<h1>Technical Bulletin</h1>	<b>High End Systems</b>	<b>Page 1/2</b>
	<b>Single Widget Software Compatibility</b>	<b>2-Oct-2015</b>	<b>Rev A</b>

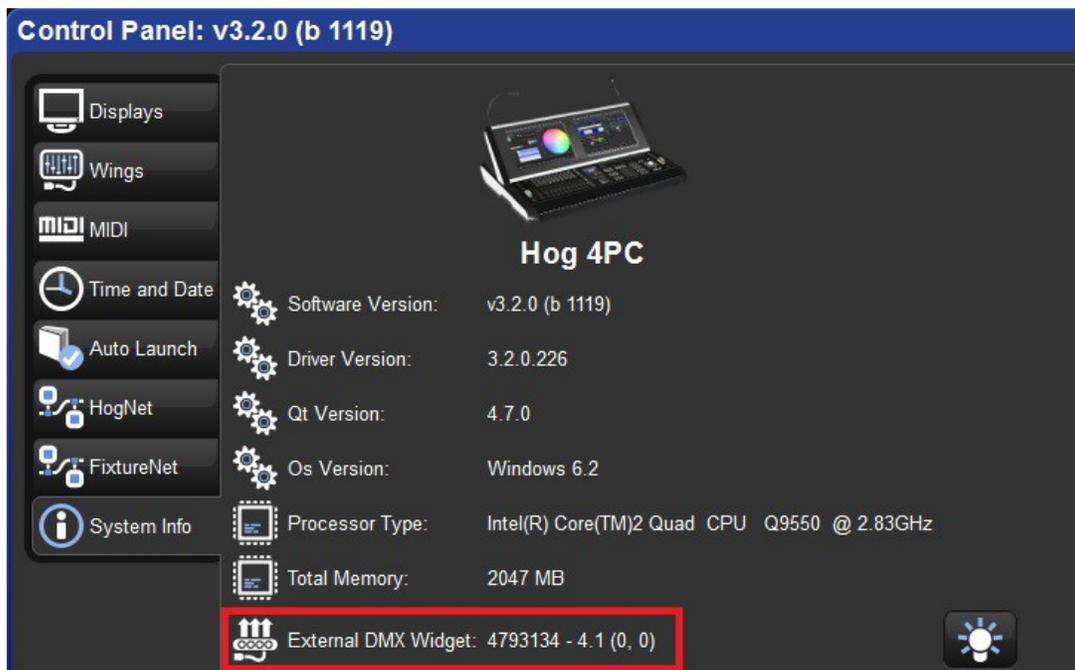
When new single widgets are seen by Hog 4 OS PRIOR to v3.2.1, in Control Panel → System Info the serial number will appear incorrect and the firmware version will be 4.1 or higher:

Instead, customers must **upgrade to Hog 4 OS v3.2.1 or later**. This will recognize the new single widget and allow immediate use of the widget.

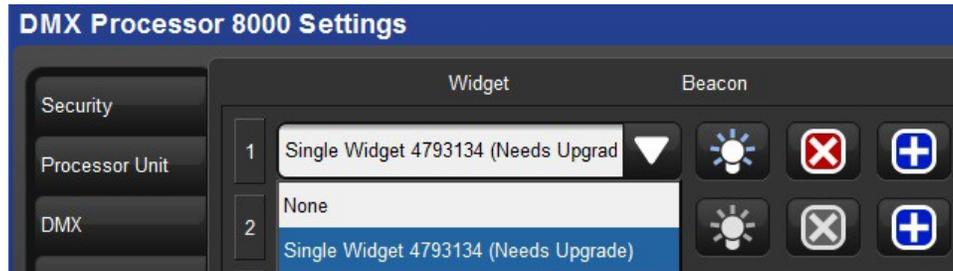
Under Network Settings → DMX Processor 8000 Settings → DMX Widgets, the serial number will appear incorrect, and the widget will indicate "Needs Upgrade":

In addition, the widget will not transmit DMX.
